**RE: Division Docket No. D-11-94
National Grid Hurricane Irene Response Assessment
Responses to Division Data Requests (Set 2)
Section I. Engineering & Design**

I. Engineering & Design
Division 2-1

Analysis of L14 Pole 54 Failure

Figure 1 Model of Structure Behavior Under Various Wind Loads

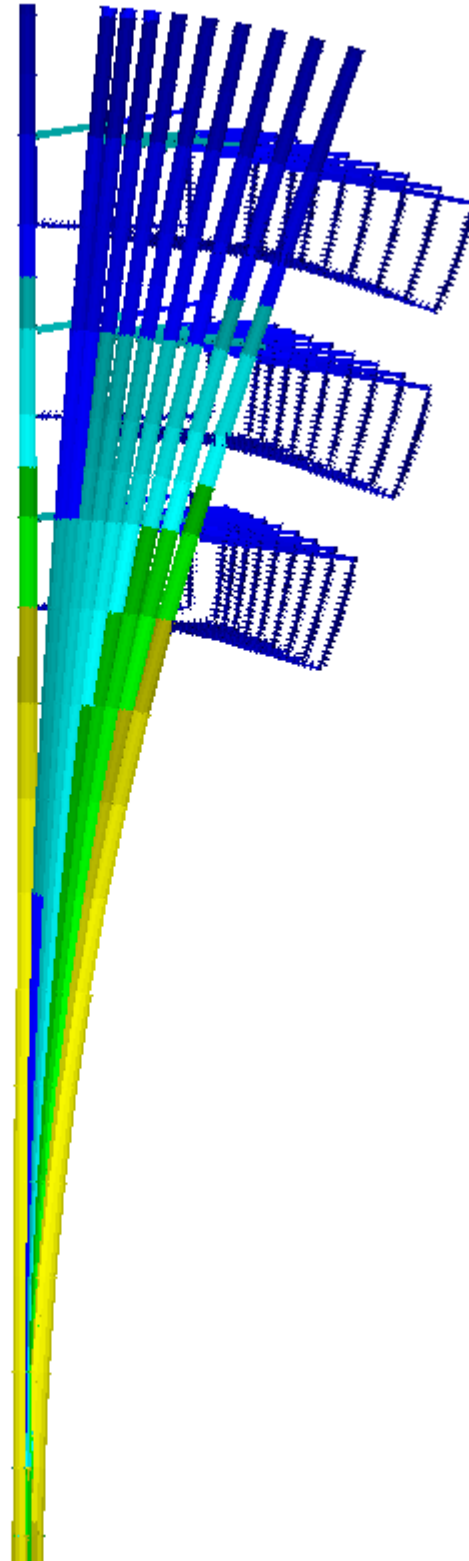
- 1.0 In August 2011 during Tropical Storm Irene, pole 54 of the L14 line failed, causing the line to fall into the adjacent M13 circuit, resulting in outages on both circuits and significant lost customer minutes. The pole failed well above the ground line, under winds believed to be in the range of 45 to 55 mph.

- 2.0 This analysis will assess the likely cause of the failure. First, the pole will be analyzed for compliance with the 1977 edition of the National Electrical Safety Code to verify proper design. Second, although not required, the pole will be analyzed using modern methods for determining the load effects of high wind storms on transmission structures, in order to assess the likelihood that the pole could have failed without the existence of prior damage.

- 7.1 Identify the maximum stress, and the location of the maximum stress, using PLS-POLE
 - 7.2 Calculate the probability of overload under this stress for an undamaged pole using the wood pole properties presented in ANSI O5.1.2008 and assuming wood pole strength variation is normally distributed
- 8.0 The results of the analysis are shown below. For the wind speeds observed during Tropical Storm Irene, the probability of overload for an undamaged pole is quite low. Therefore, it can be concluded with a high degree of certainty that the primary cause of failure was pre-existing damage, deterioration or defect, and not inadequate design.

- 9.0 The broken pole was not retained, and no photographs of the broken area of the pole were taken, so any discussion of the specific type of damage present would be speculative at best. Given that the failure occurred well above the ground line, decay seems unlikely. Fatigue stress on the pole due to repeated wind loading cycles may be possible. Acute mechanical damage due to wood pecker nesting or some other cause could also be possible.

O-Calc® Pro Analysis Report

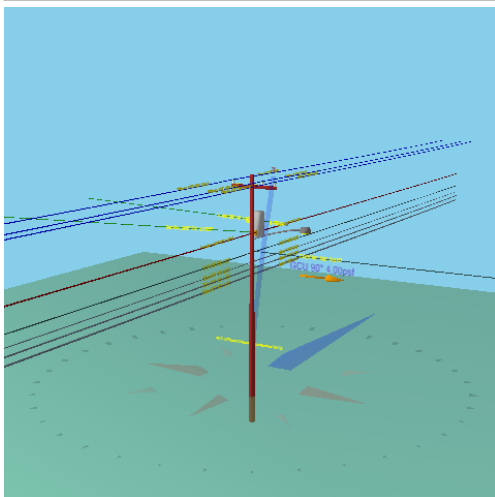
Provide a copy of an example pole strength calculation for one of the joint use poles that blew over or failed and include any “make ready” work order documentation that exists.

Please see the document entitled “O-Calc® Pro Analysis Report” in Attachment DIV 2-12 as an example of a pole strength calculation for Pole 15 at Grand Avenue, Cranston. National Grid is not aware of any associated “make ready” documentation for this location.

Pole Capacity Utilization		Height	Wind Angle
Maximum:	66.7%	0.0 ft	90.0°
Groundline:	66.7%	0.0 ft	90.0°
Vertical:	20.2%	22.4 ft	90.0°
